Change of socket material and integration of V-Lock cord retaining feature as standard.

Product Change Notification						C20F snap-in and screw-on rear version PCN	
owner	creation date	release date	released by	change order no	rev	page	D10-015-728
sariogar	09.05.2017	30.10.2017	blumhe	2010167	A	1 of 2

Old product appearance	New product appearance
<p>Snap-in mounting from front side</p>  	<p>Snap-in mounting from front side</p>  
<p>Screw-on mounting from rear side</p>  	<p>Screw-on mounting from rear side</p>

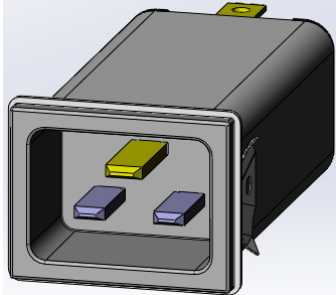
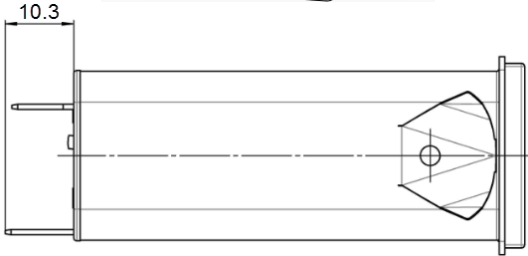
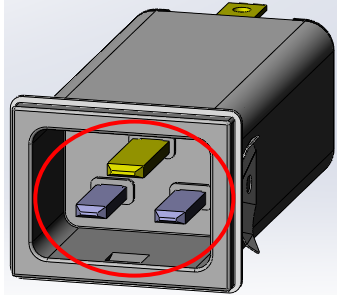
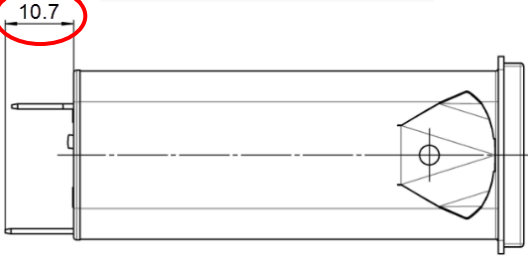
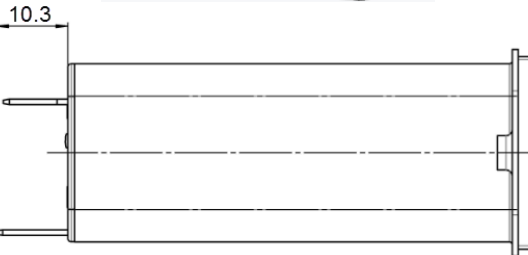
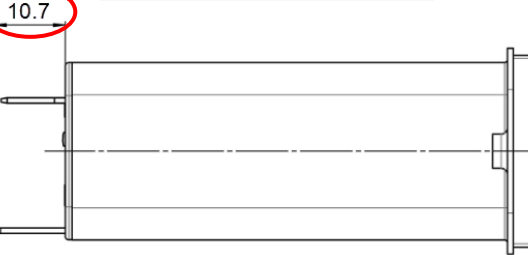
- Socket material change from PA6 to PA66/6 to pass the enhanced requirements of glow wire test acc. to IEC 60695-2-12 and -13
- V-Lock cord retaining integrated as standard feature (not an option anymore)

Form	Yes	Socket has notch for V-Lock cord retaining, new form on extended socket dimension and socket base.
Fit	Yes	Installation depth is 0.40 mm extended.
Function	Yes	V-Lock feature is standard (not an option anymore)
Production Site	No	There is no change of the production site
Product Label	No	No label change
Customer Action	Yes	PE-Terminal is 0.4mm longer. Check installation depth in the application. Change SCHURTER part number if affected.

As the V-Lock notch and material for enhanced glow wire tests will be standard features, the material numbers with index .21 are obsolete and will be replaced by the standard numbers:

C20F.0112.21 ⇨ C20F.0112 | C20F.0224.21 ⇨ C20F.0224
C20F.0222.21 ⇨ C20F.0222
